APPENDIX G
MITIGATING STRATEGIES ASSESSMENT FOR NEW FLOOD HAZARD INFORMATION ASSESSMENT

G.1 INTRODUCTION

Figure 1 – Mitigation for New Flood Hazard Information and Mitigating Strategies Assessment Flow Chart

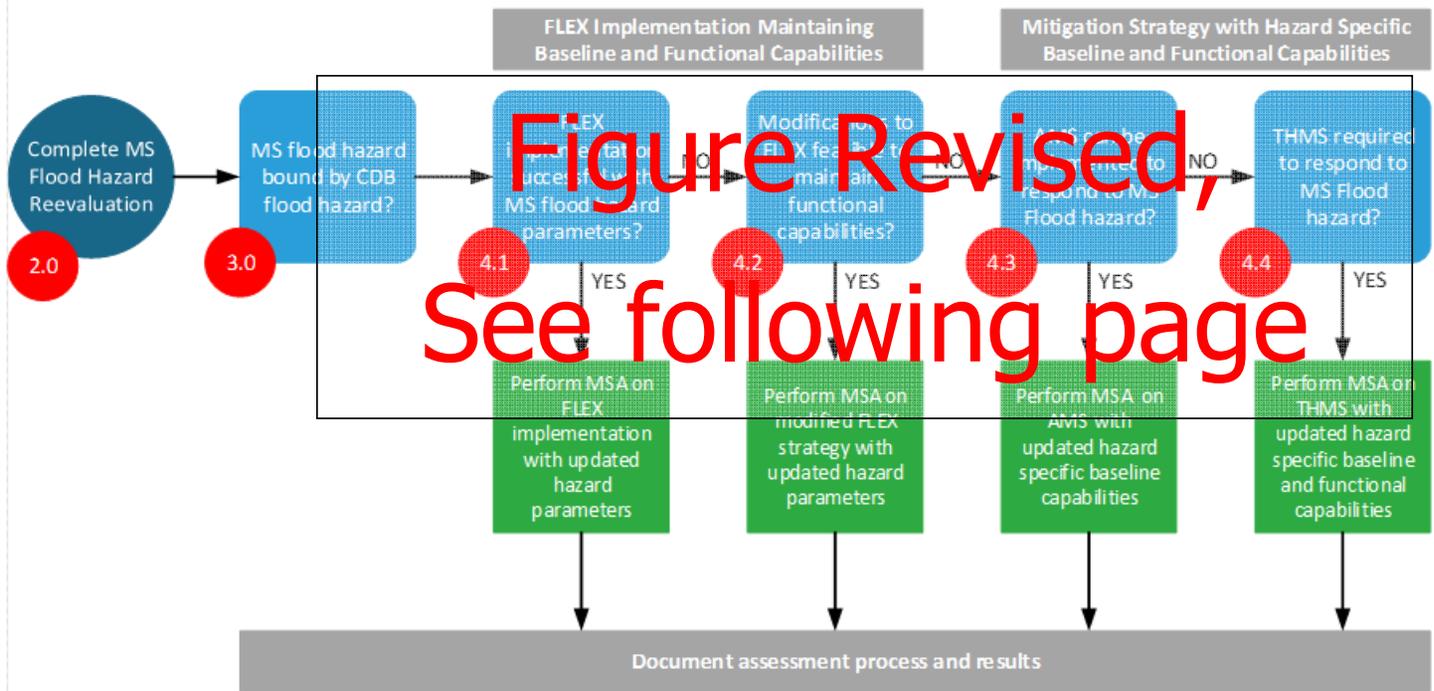
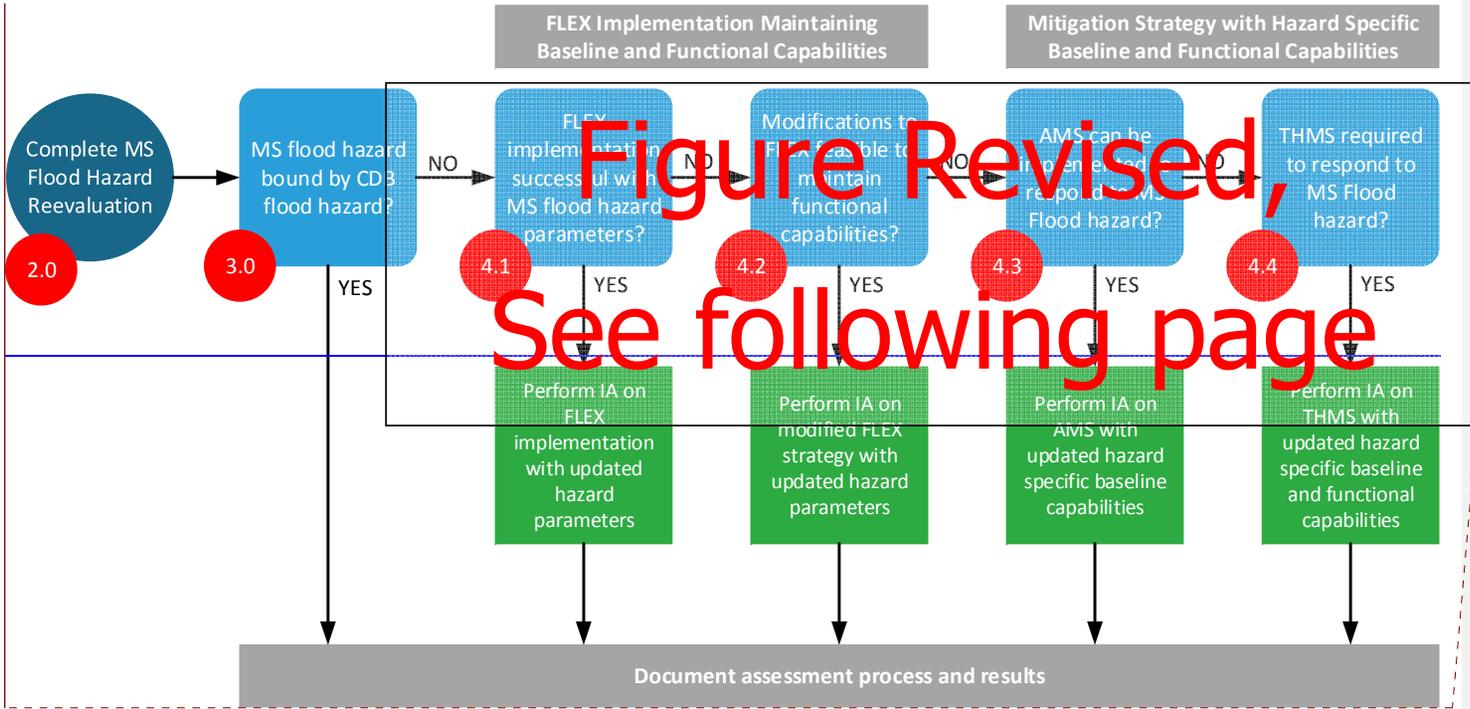
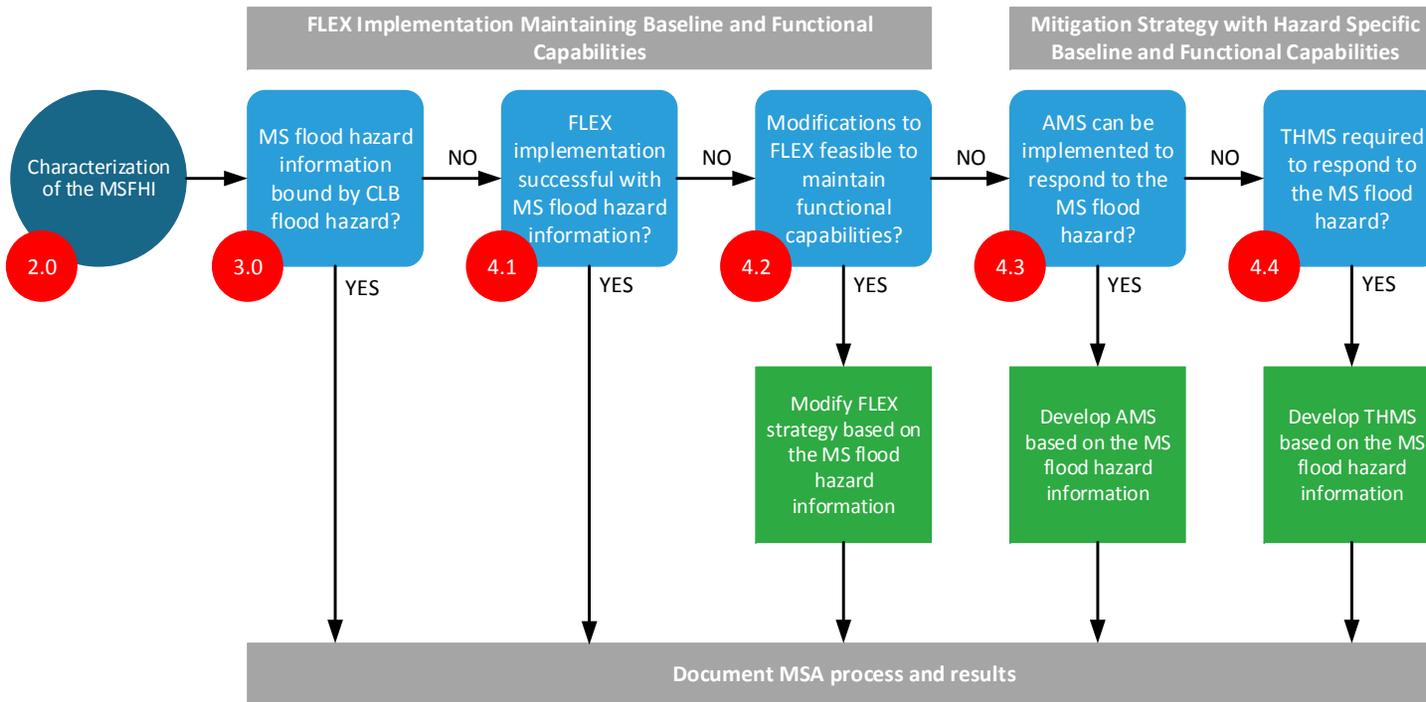
Comment [SSP12]: Use G.x section numbers in the figures.

What about a "Yes" result for the bounded question? Is that not a possible outcome? Show that this would be the MSA or include in this first block.
FFTF – agree, we will add a green block under 3.0 to illustrate the need to document this conclusion.

Comment [NRC13]: The whole lower section of this graph should discuss implementation plans. WRT IAs it should just say "candidate for IA."

Comment [NRC14]: Should this figure include multiple arrows... to reflect evaluation of multiple flooding aspects / hazards?

FFTF - No intent to change – chart is for simplicity not guidance. IA should be removed from the chart. See next page for final chart.

FFTF - No intent to change – chart is for simplicity not guidance. See next page for final chart.

Figure 2 – Alternate Mitigation Strategy Evaluation Flowchart

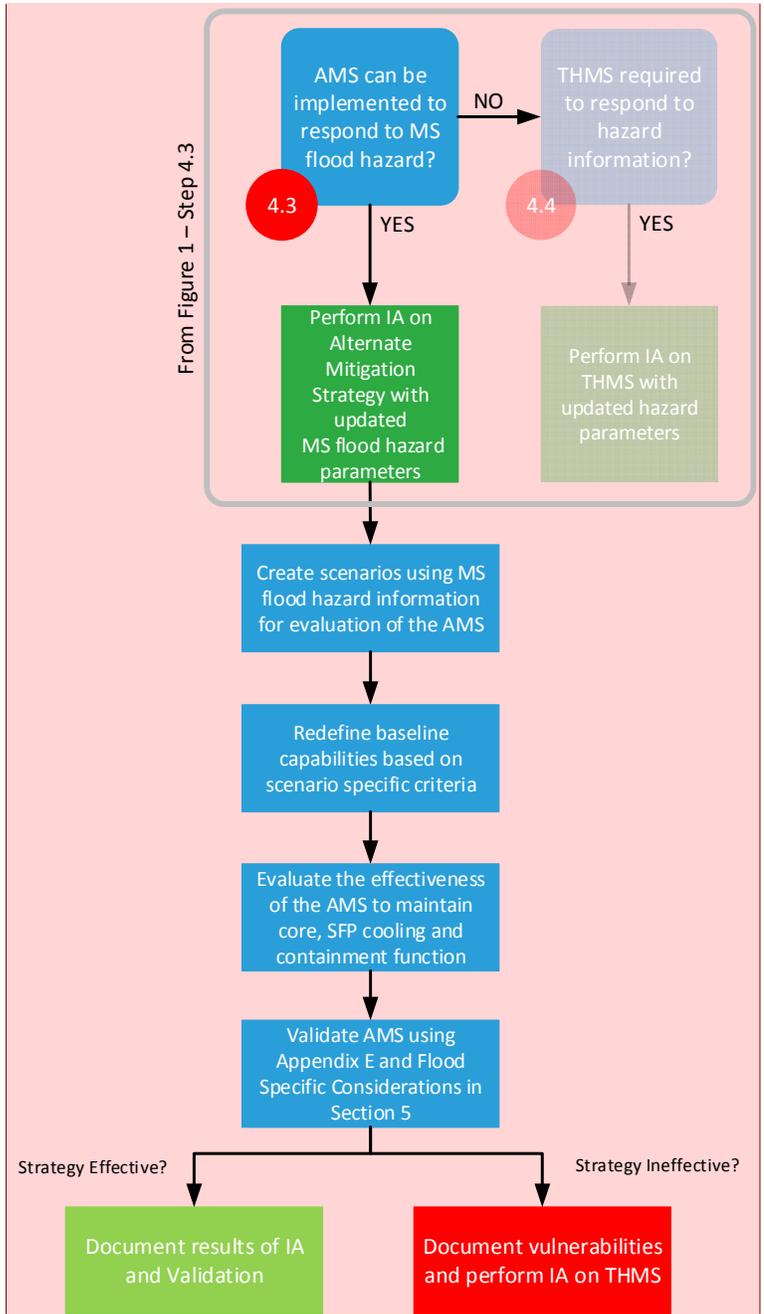
Comment [SSP71]: Change IA to MSA.
 Change section numbers and "Step" numbers to G.x, etc...
 FFTF _ OK, will change the figure after the rest of the appendix is finalized.

Figure 3 – Targeted Hazard Mitigation Strategy Evaluation Flowchart

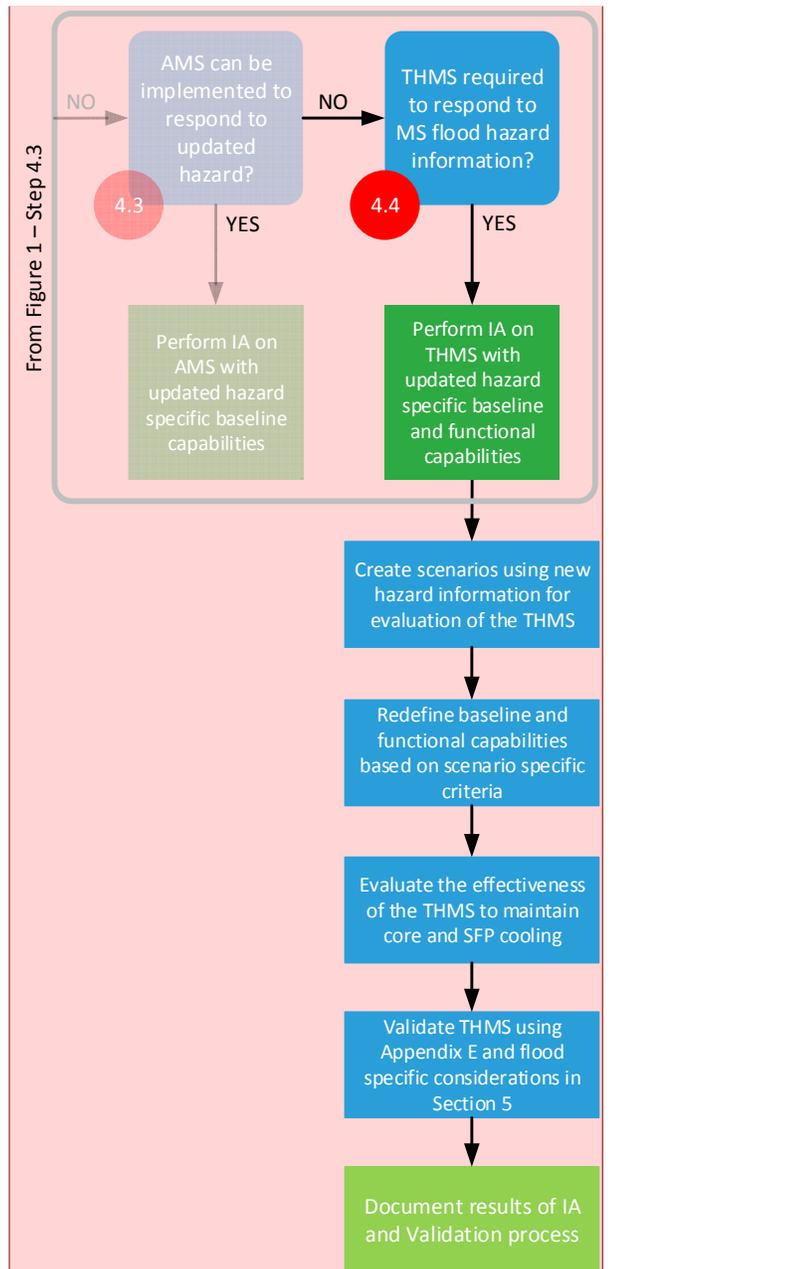
Comment [SSP77]: Change IA to MSA.

FFTF – OK, figures will be revised to be consistent with the final text.
